Luas Finglas

Railway Order Statutory Consultation

Response to Submissions Received

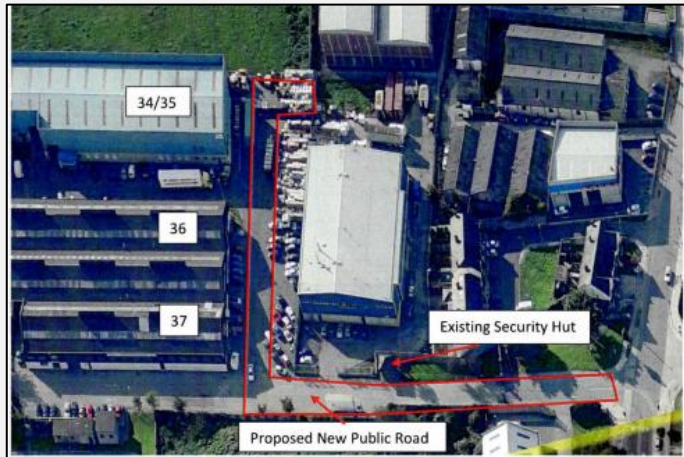
6	4	<p>Noise concerns</p> <p>“During a recent meeting, potential noise from passing LRVs was discussed. While we appreciate the proposal to plant additional trees near the counselling and training rooms, we are concerned that this measure alone will not adequately mitigate noise. Could you provide assurances that the building's interior will remain unaffected by LRV noise?”</p>	<p>The Finglas Youth Resource Centre (FYRC) have raised concerns regarding noise impacts on their premises during the operation of the Luas. Section 15.4.1.5 of Volume 3 of the EIAR assesses the operational phase noise impacts of the proposed Scheme. Specifically, noise model receptors R086 and R087 are located at the external façades of the FYRC on the eastern and southern elevations respectively. Figure 15.2 of Volume 4 of the EIAR illustrates the location of this and all other noise model receptors.</p> <p>The calculated noise level during operation of the proposed Scheme at R086 and R087 is detailed in Tables 15-32 and 15-33 of Volume 3 of the EIAR for the opening and design years respectively. These tables present the following noise levels,</p> <ul style="list-style-type: none">Daytime Noise dB LAeq,16hrDaytime Peak Hour Noise dB LAeq,1hrNight-time Noise dB LnightNight-time Peak Hour Noise dB LAeq,1hr <p>In the case of receptors R086 and R087 only the daytime noise levels are relevant as the building is not operated at night. The daytime noise levels due to operation of the Luas range from 50 – 52dB LAeq,16hr at R087 on the southern facade and are of the order of 59 dB LAeq,16hr at R086 on the southern facade. This absolute noise level is lower than the threshold of 60dB for daytime noise as described in Section 15.2.4.8 of Volume 3 of the EIAR for commercial properties.</p> <p>Furthermore, to put the calculated noise level in context reference is made to the noise monitoring described in Section 15.3.1 of Volume 3 of the EIAR. The closest monitoring location to the FYRC was AT6, as illustrated in Figure 15.1 of Volume 4 of the EIAR, which is on Mellowes Rd adjacent to the Finglas Counselling Service. Noise levels measured at this location were of the order of 68dB during the daytime. Therefore, the new noise from Luas operation will be several orders of magnitude lower than the existing baseline noise environment due to road traffic.</p> <p>Finally, in the vicinity of the FYRC the proposed track operates at low speed due to the proximity to Finglas Village Stop and the curvature of the track. The curvature of the track at this location has been identified as a potential risk in terms of the generation of additional noise and vibration during operation. Therefore, mitigation measures in the form of floating slab track have been provided in this location as illustrated in Figures 15-11 and 15-12 of Volume 3 of the EIAR.</p> <p>In conclusion the noise impact at the FYRC has been robustly assessed in the EIAR submitted with the RO and mitigation in the form of floating slab track has been provided. The noise impact at this location is concluded to be not significant.</p>

7	4	<p>“We request the inclusion of proven soundproofing measures, such as cladding and/or soundproof windows, to minimise the impact. Given the proximity of the LRV path to the building, frequent LRV passes (approximately every seven minutes) could disrupt essential activities such as counselling, meditation, and training sessions.”</p>	<p>The assessment contained within Chapter 15 of Volume 3 of the EIAR submitted has demonstrated that the residual noise and vibration impact of both the operation and construction of the proposed Scheme is not significant and in many cases the impact is slight. Sound insulation measures to buildings along the proposed Scheme are therefore not required.</p>
8	4	<p>Safety</p> <p>“Front Door Security - The "Finglas Village Stop" is positioned at the heart of the new line, which will likely increase footfall outside the centre. While we have historically operated an "open door" policy, the increase in activity could result in additional risk factors to the centre. In light of this, and to align with child protection guidelines, we may need to transition to an "invitation-only" access policy. Our current front door is not fit for</p>	<p>Please refer to response to item No 5 above and No 9 below with regard to security during the operation of Luas Finglas. Irrespective, TII is satisfied to continue to consult with Finglas Youth Research Centre with regard to the proposed construction and operation of Luas Finglas.</p>

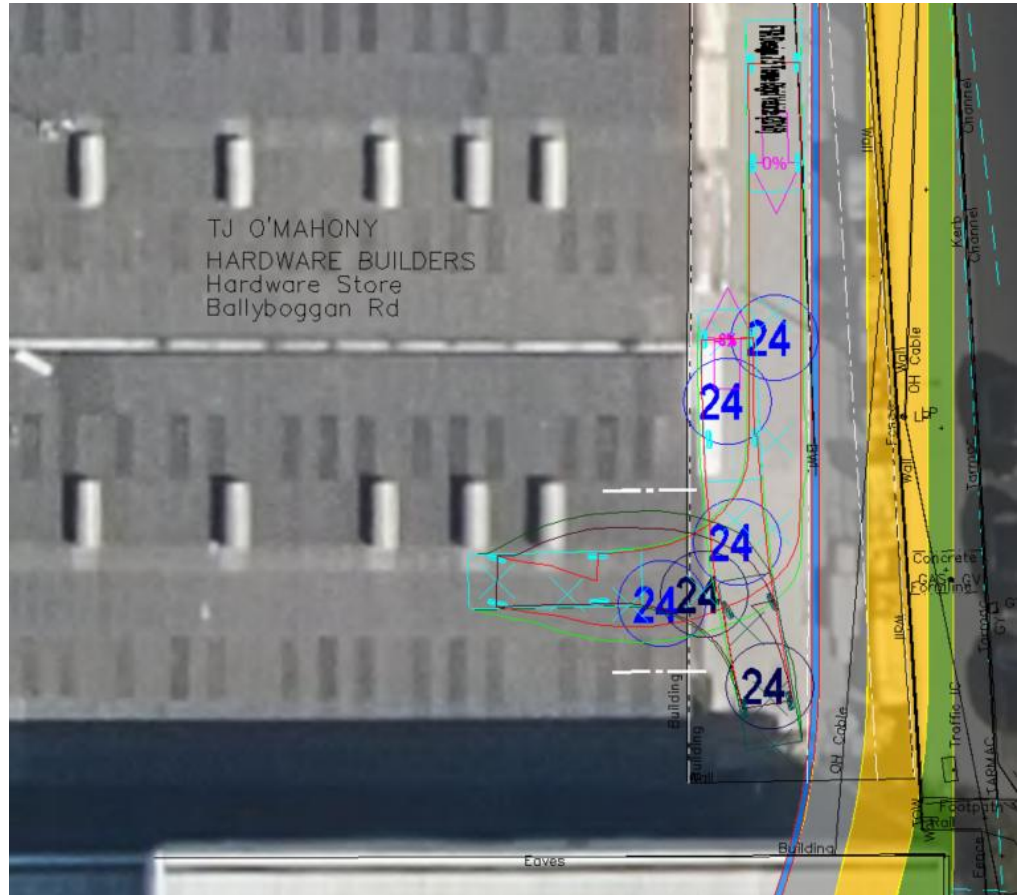
2	8	<p>"It is considered that the these works as part of the proposed development will significantly impact the ability of the subject lands to carry out their daily operations by impeding access to the site and resulting in complications for the future development of the site."</p>	<p>Please refer to response to Item No. 1 above.</p>
3	9	<p>"We would therefore request that the proposed works with regard to the subject lands should be revised to provide for an alternative solution to the route which is proposed within the boundary of the subject site, which would provide for a significant reduction of the impacts of the works on the subject lands."</p>	<p>The proposed alternative access via McKee Avenue as indicated on alignment drawing D1 32 GA 1-2 is in line with the master plan for Jamestown Business Park. TII has included land take within the subject lands to ensure a direct link to allow public access to the adjoining business premises. i</p>
